**Freescale Semiconductor, Inc.**

Errata to MC68302 User's Manual

**Figure 6-9. External Master Internal Asynchronous Write Cycle Timing Diagram**

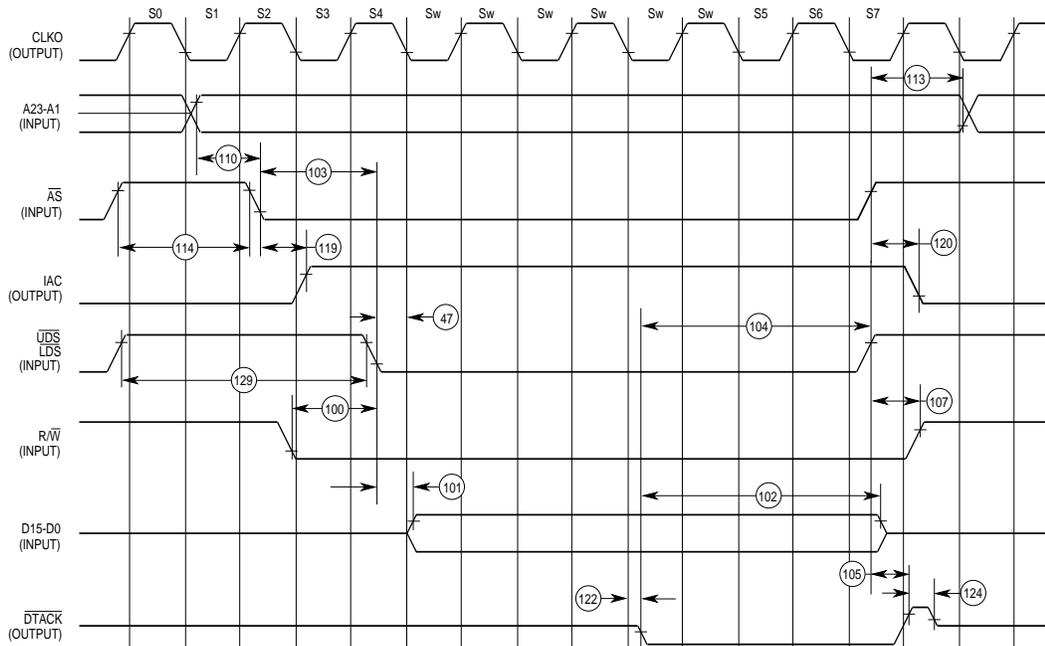
6.10, Page 6-18 Replace Figure 6-9 with the following:

7.2.1, Page 7-4

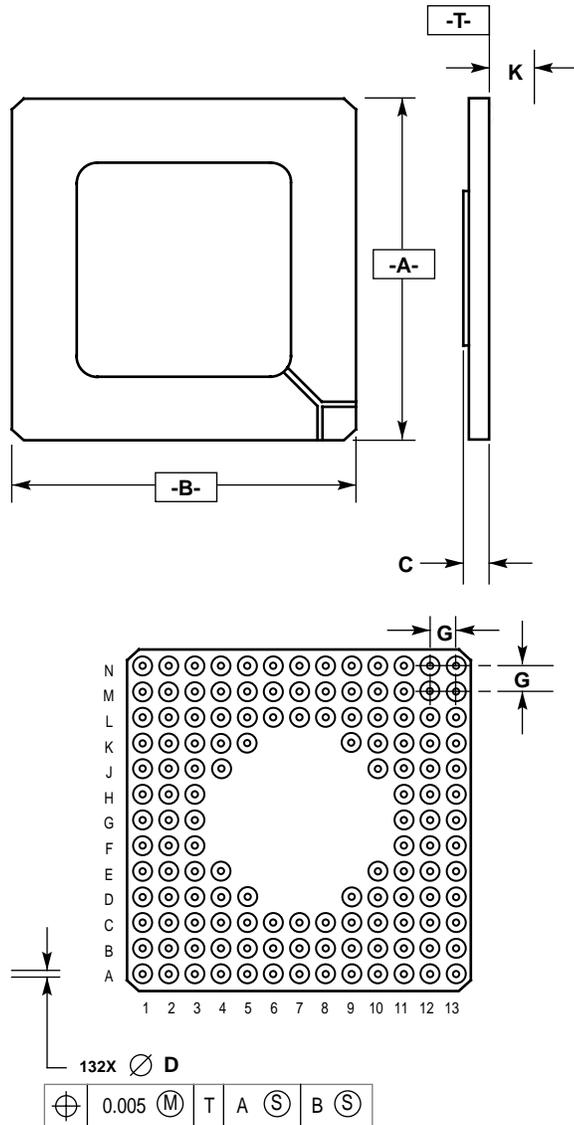
Replace the PGA package case drawings with the following:

- NOTES:
1. DIMENSIONING AND TOLERANCING PER ANSI Y14.5M, 1982.
  2. CONTROLLING DIMENSION: INCH.

DIM	INCHES	
	MIN	MAX
A	1.340	1.380
B	1.340	1.380
C	0.100	0.150
D	0.017	0.022
G	0.100 BSC	
K	0.170	0.195
